REGULATION NO.125 (Forward field of vision of drivers)

Proposal to review the requirements for forward field of vision in Regulation No.125

Figure

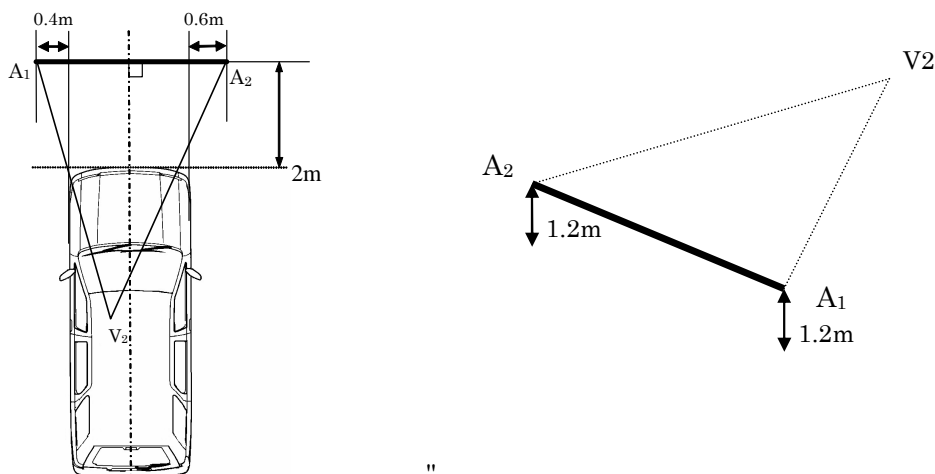
Paragraph 5.1.3. amend to read (including the new figures):

"Other than the obstructions created by the A pillars, the fixed or movable vent or side window division bars, outside radio aerials, ~~rear-view~~ mirrors and windscreen wipers, there should be no obstruction in the driver's 180 degrees forward direct field of vision below a horizontal plane passing through  $V_1$ , and above three planes through  $V_2$ , one being perpendicular to the plane X-Z and declining forward 4 degrees below the horizontal, and the other two being perpendicular to the plane Y-Z and declining 4 degrees below the horizontal (see Annex 4, appendix, figure 4).

**Other than the obstructions created by the A pillars, outside radio aerials, mirrors and windscreen wipers, there should be no obstruction in a plane passing through the three points  $A_1$ ,  $A_2$ , and  $V_2$ , where  $A_1$  is a point 0.4 m outside of the outermost edge of the vehicle on the driver's side on a line parallel to the horizontal plane and perpendicular to the central axis of the vehicle and situated 2 m in front of the foremost edge of the vehicle and 1.2 m above ground, and  $A_2$  is a point 0.6 m outside of the outermost edge on the other side of the vehicle on the said line.**

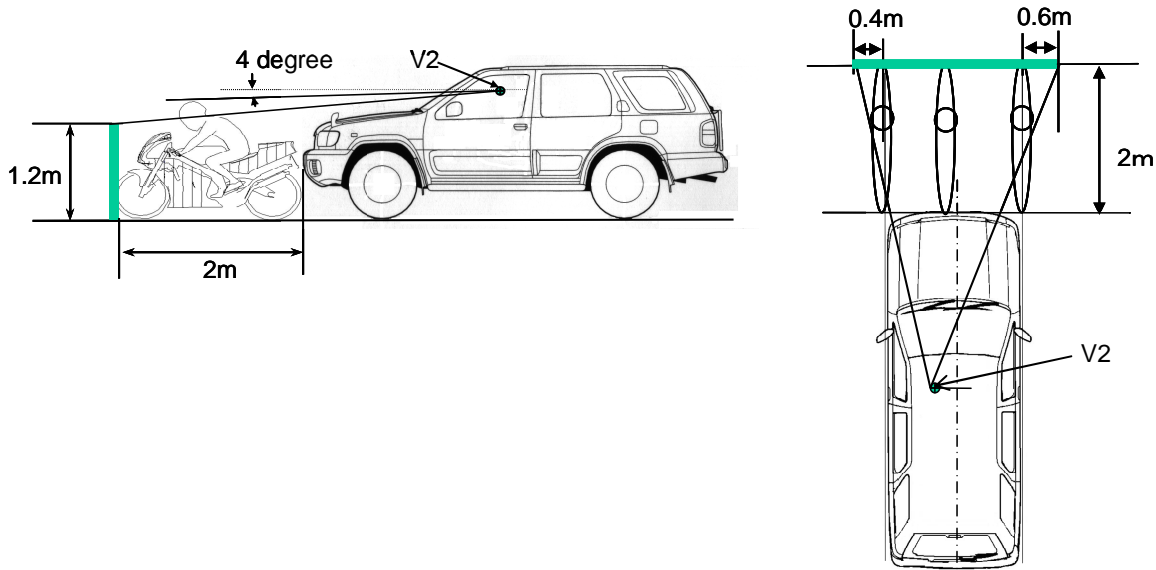
(2) For vehicles with high ground clearances, V2 is also high, which means it is not always possible for the driver to perceive small vehicles in front, such as motorcycles, that come below the plane 4 degrees below V2. This new provision will enable the forward field of vision to be ensured even for high-ground-clearance vehicles (see figures below).
